**ADDENDUM No. 1**

**REQUEST FOR QUOTATION No.:** 1220-040-2022-077

**TITLE:** GUILDFORD LIBRARY: AIR HANDLING UNITS  
REPLACEMENTS

**Guildford Library – Equipment Upgrades**  
085b-067-21

PROJECT NO. 085b-067-21  
 DRAWING NO. **M1.01**

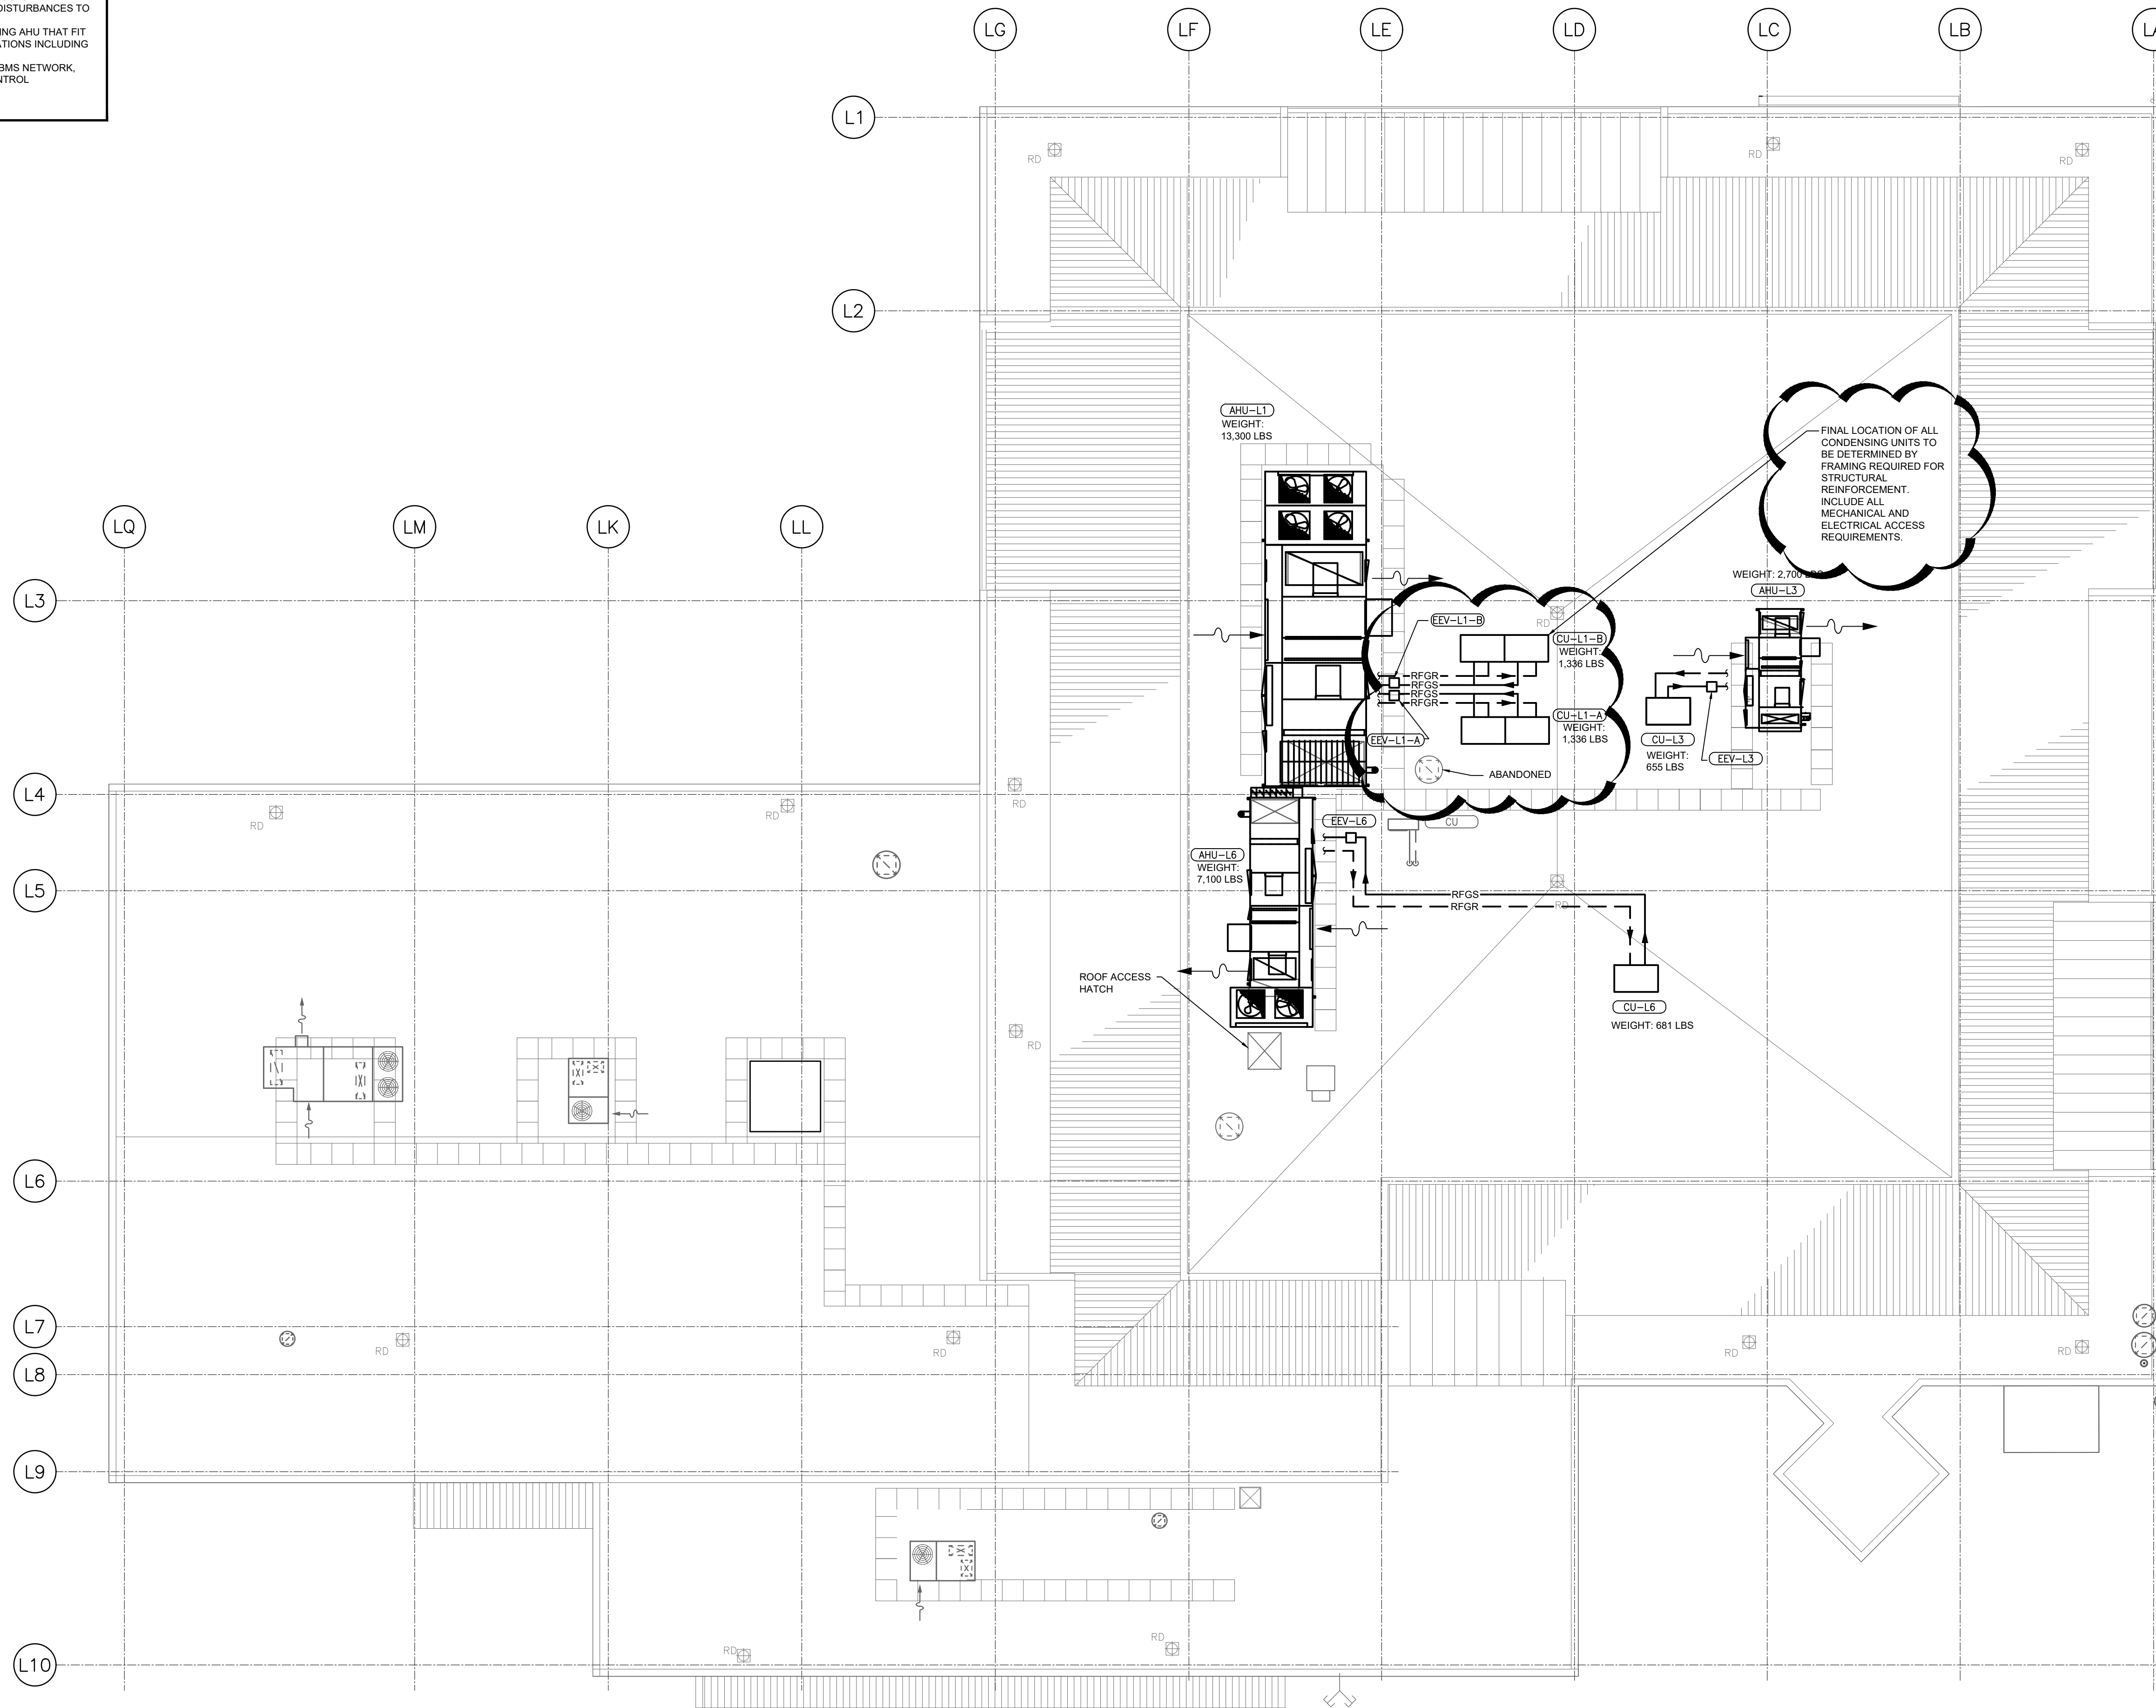
**1.2 Drawing No.: M1.01**

- .1 Add:
  - .1 AHU schedule, notes 18,19, 20, 21,22
- .2 Revise:
  - .1 Remarks, all to include notes 18 thru 22

18 UNIT TO COME WITH REFRIGERANT SPLIT COIL, 358.4 MBH OUTPUT EACH  
 19 GAS PRV TO BE RATED FOR 7 IN WC OF PRESSURE  
 20 STANDARD EFFICIENCY SHOWN (80%) FOR HEATING COIL, HIGH EFFICIENCY BURNERS TO BE 91% EFFICIENT  
 21 INCLUDE SEPARATE PRICING FOR HIGH EFFICIENCY BURNERS. INCLUDE BUILT IN CONDENSATE NEUTRALIZER WITH PRICING.  
 22 UNITS TO COME WITH A SEISMIC CURB AS A SEPARATE PRICE.

**PROJECT NO.:** 085b-067-21  
**DRAWING NO.:** M2.02

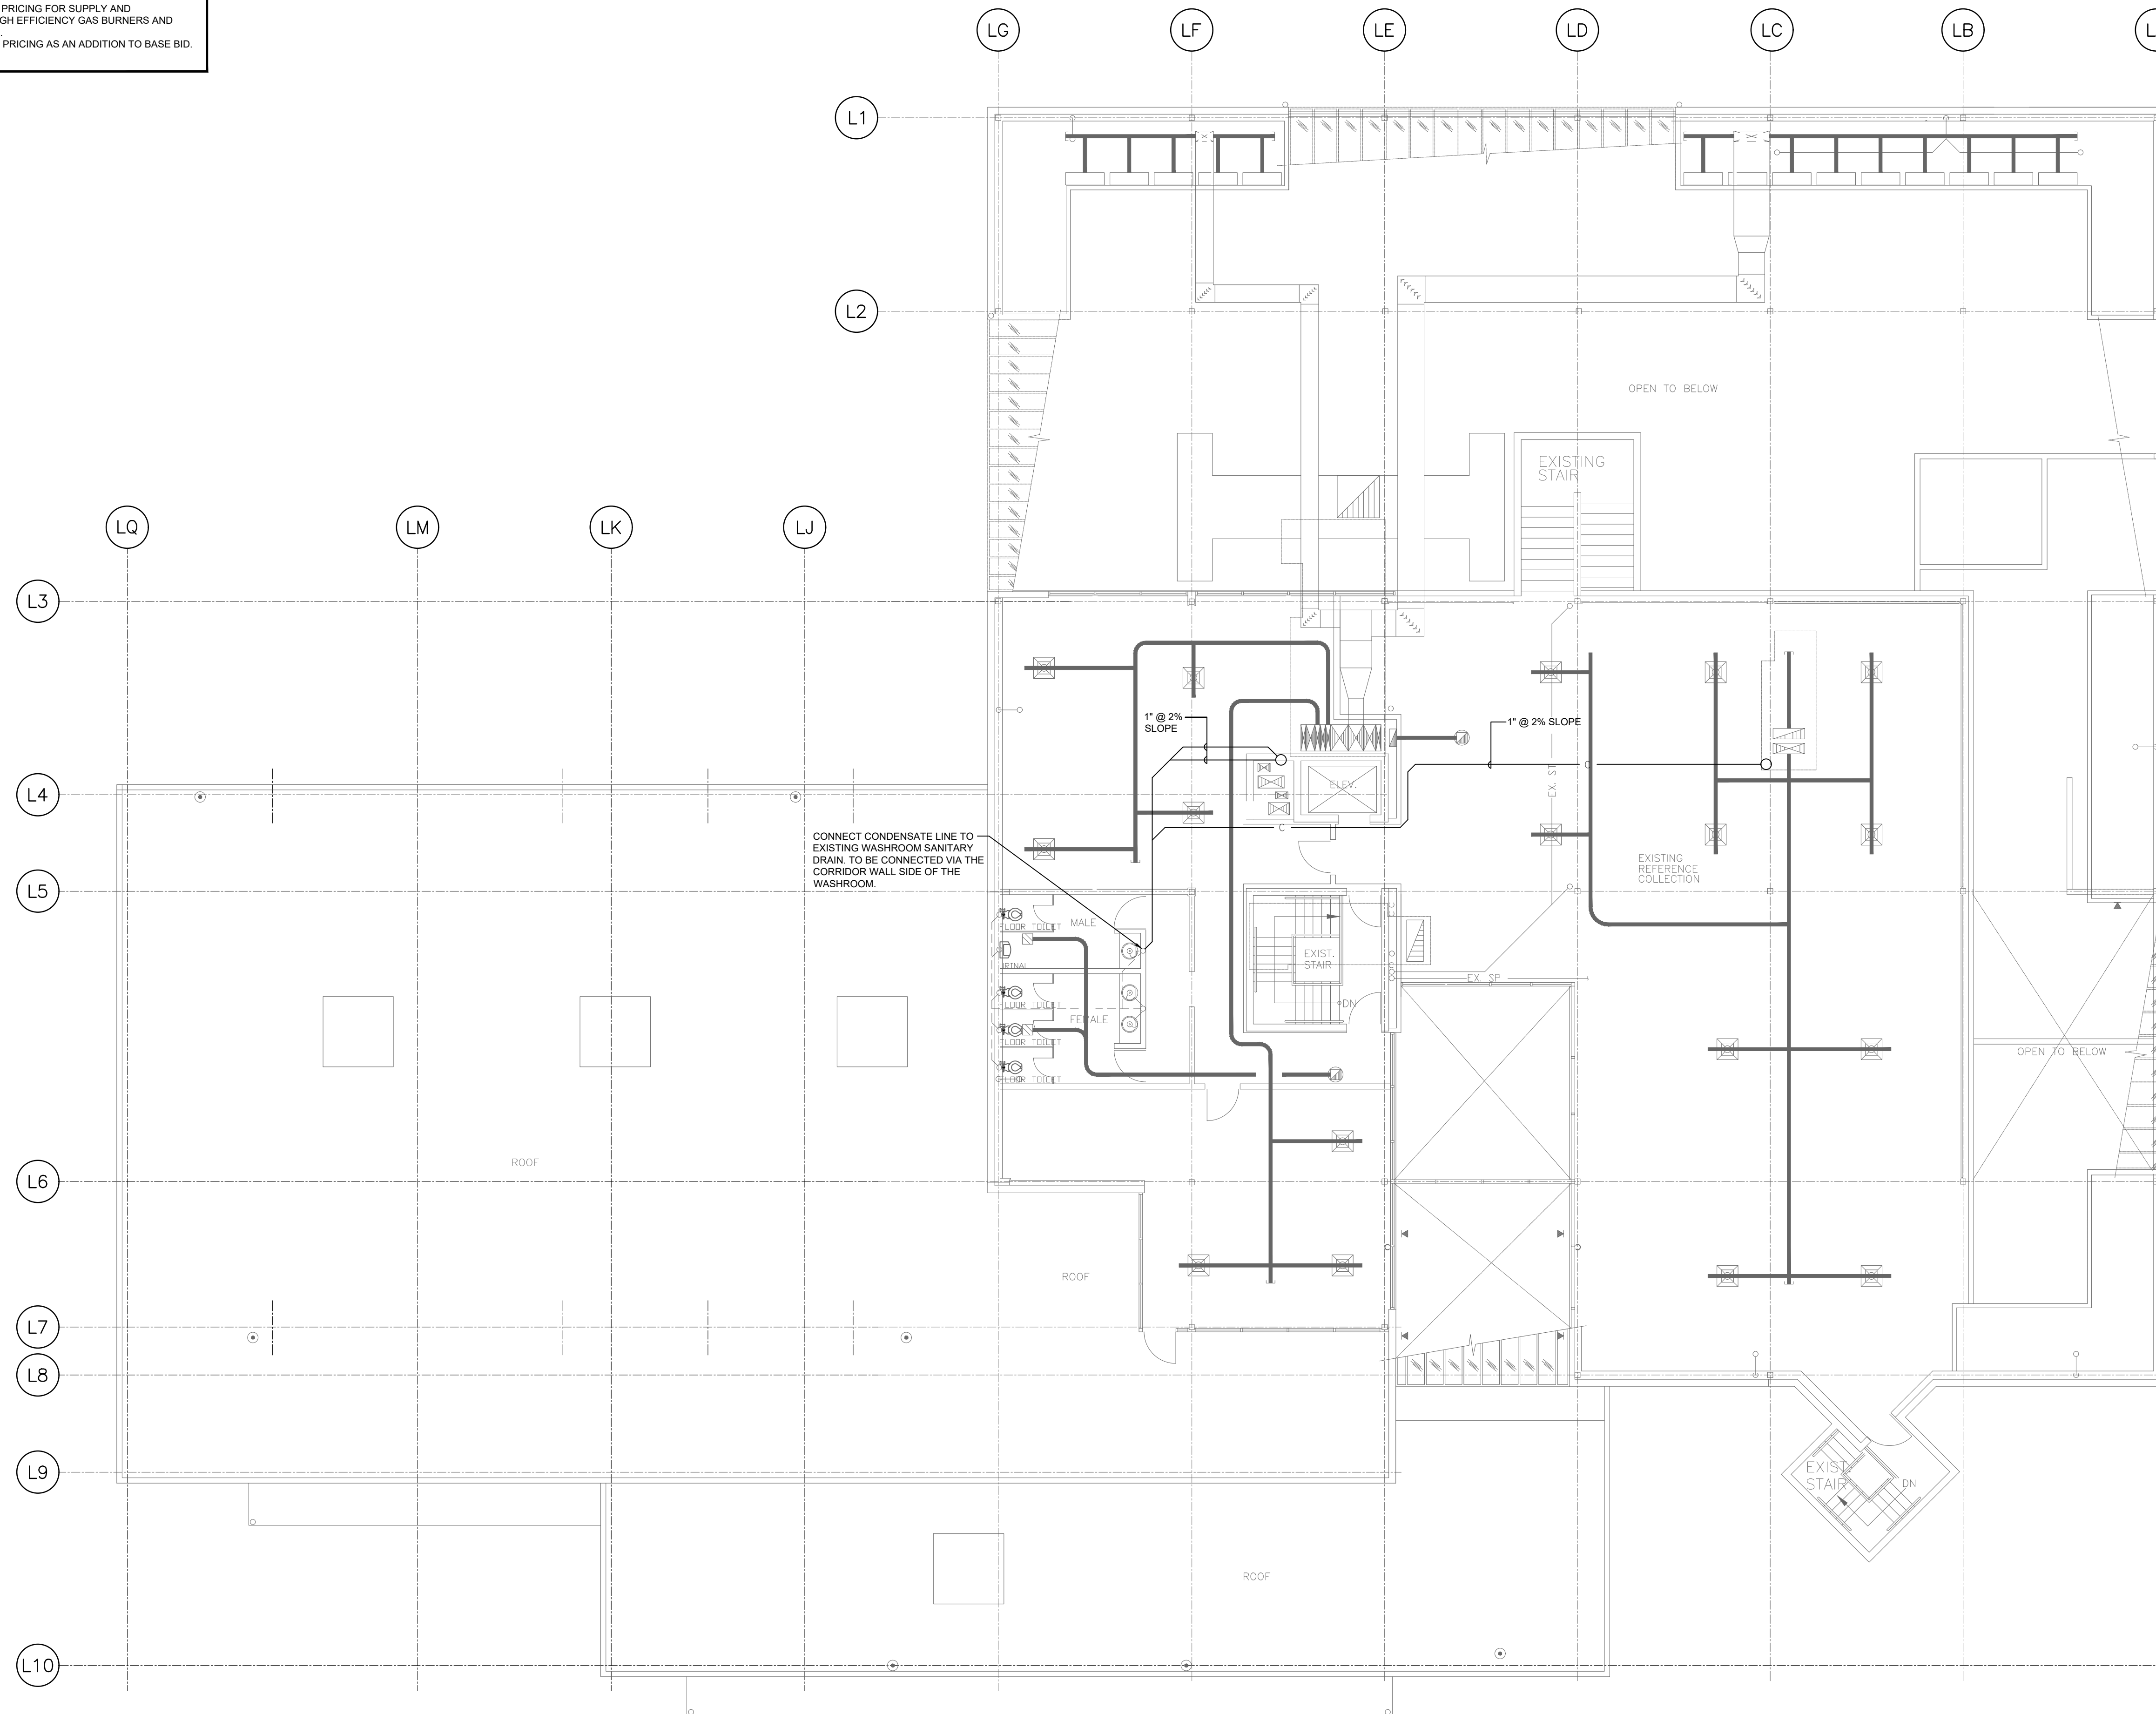
**1.3 Drawing No.: M2.02**

- .1 Add:
  - .1 Note regarding condensing unit final location
- .2 Revise:
  - .1 Condensing units CU-L1-A and CU-L1-B location. Units shifted over east to allow for coil pull clearance of AHU-L1.
  - .2 Equipment tag EEV-L1-B to EEV-L1-A
